REMARKS

In the Office Action dated January 11, 2006, the Examiner stated that the title of the invention is not descriptive and a new title is required that is clearly indicative of the invention to which the claims are directed.

FIG. 2A
(PRIOR ART)

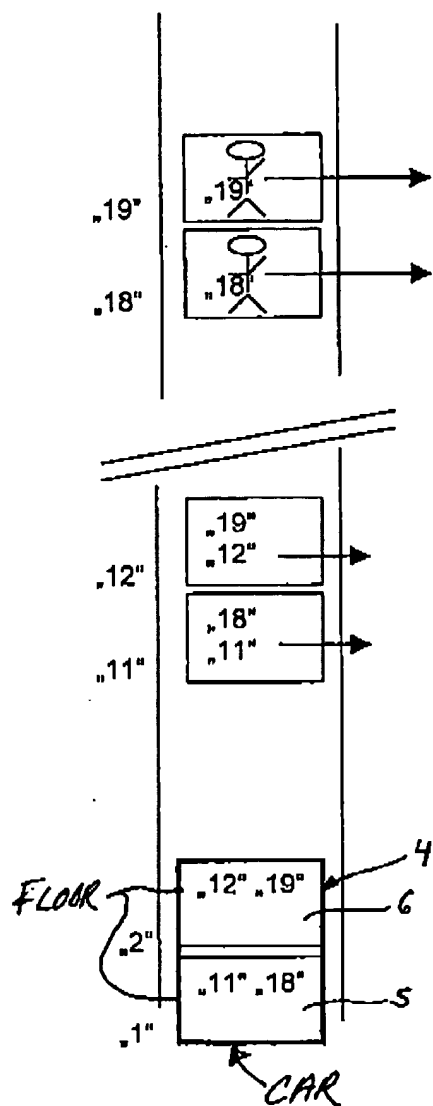
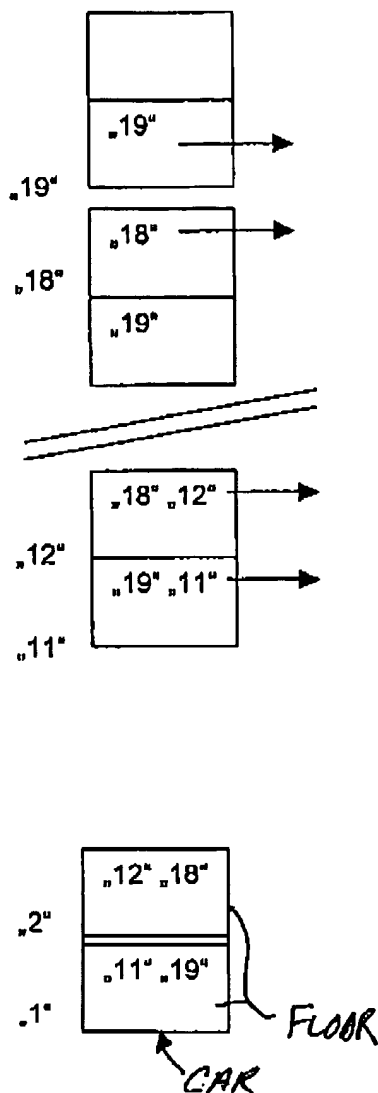
The Examiner objected to the drawings are objected because the blank rectangular boxes and/or merely numbered boxes of figures 1-3 must be labeled. The Examiner stated that Fig. 2A should be designated by a legend such as --Prior Art-- because only that which is old is illustrated.

Examiner. The blank rectangular boxes are labeled and the "Prior Art" legend is added to Fig. 2. Upon approval by the Examiner, Applicant will file replacement sheets.
